WESTLAKE PLANNING COMMISSION
STAFF REPORT
9/10/26

Northmoor Studios final development plan, 31207 Viking Parkway, PP#21103001, Ward 3

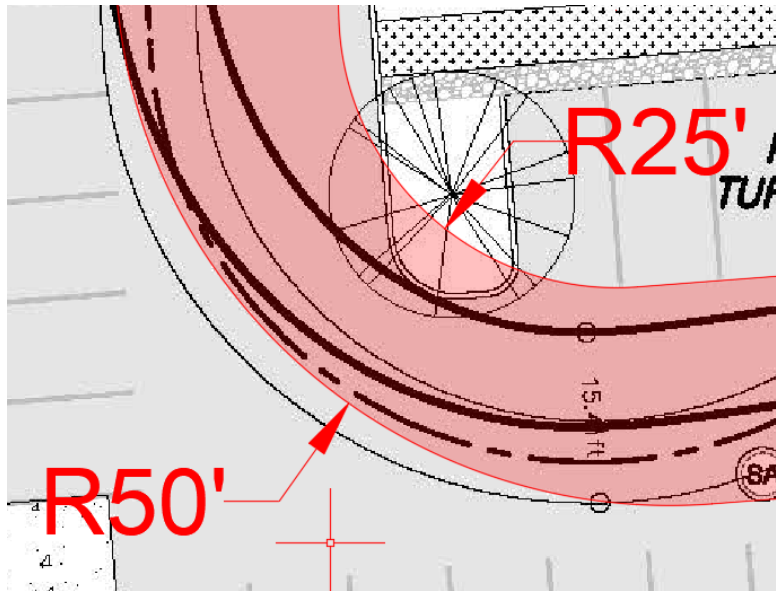
- AS100, Architectural Site Plan (conceptual and final)
 - Fire truck access between buildings indicated (Grasscrete pavers - Fire Department requires hard surface)

- Phasing has changed to include the easternmost building and associated parking in the second phase
 - Tenant parking (phase 1) reduced from 103 to 60 with 27 additional spaces in phase 2

- Tenant landbanked parking for phase 2 reduced from 41 to 39
 - New trees shown
 - Monument sign in same location as conceptual plan (future sign plan will be submitted for approval)

- Workshop building size increase from 3,850 SF to 5,200 SF
 - Workshop parking reduced from 16 spaces to 15 spaces
 - Dumpster enclosure locations indicated

- Sidewalk connection to existing added to the south; the east connection to existing previously shown is no longer depicted but is assumed to remain.
